Remarks

This amendment responds to the official action mailed November 1, 2006, and includes a petition for extension under 37 C.F.R. §1.136(a) and the required official fee.

Docket No.: D4700-396
[P 42230 WO/US]

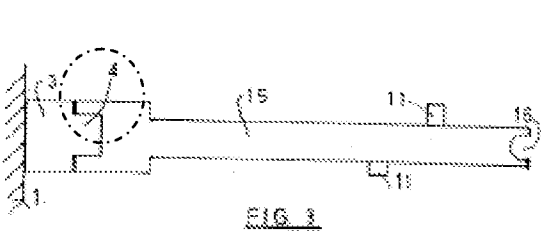
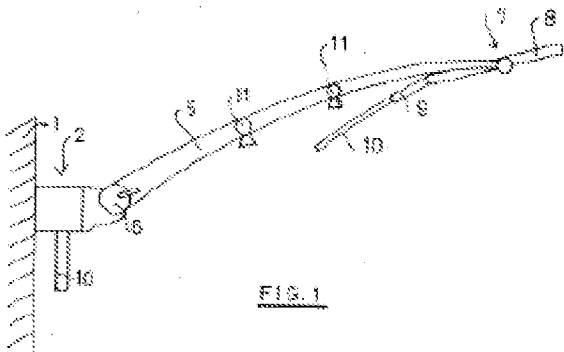
Regarding the lack of an illustration of quick connect couplers as such, claim 11 has been canceled, without prejudice. Regarding illustration of a pivot axis, the original illustration in Fig. 2 has aligned protrusions that in conjunction with the specification can be seen to define the ends of a pivot axis. Applicant proposes to add a dashed line and to label the pivot axis. The term “linkage,” which might be construed as a multi-part mechanism, has been canceled from claim 12, which now generally recites a pivotal connection. These changes resolve each of the matters noted. No new matter is presented.

With respect to reference numbers, number 3 at page 5, line 9 refers to the console 3, which number already appears in Fig. 2. Number 4, for the protrusion of console 3, mentioned at page 5, line 12, is to be added to Fig. 3 identifying the only part of console 3 that protrudes. No new matter is presented. The receptacle 13 for the shower head 8, mentioned at page 6, line 6, and the tips 12 of the tines 14 of the arm 5, are to be added to Fig. 2. These also are shown to identify the parts to which the respective terms clearly refer. The objections to the drawings are thus obviated. No new matter is presented.

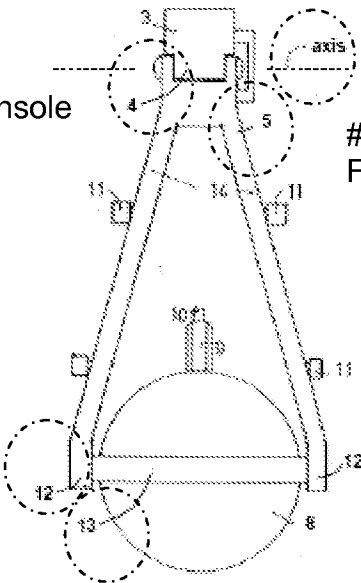
#4 – protrusion
of console 3
p. 5, line 12

Pivot axis
p. 5, line 12

#4 – protrusion of console
p. 5, line 12

#5 - arm
Fig. 1

#13 – receptacle
for shower head 8
p. 6, line 6

#12 – tine tips
p. 6, line 7
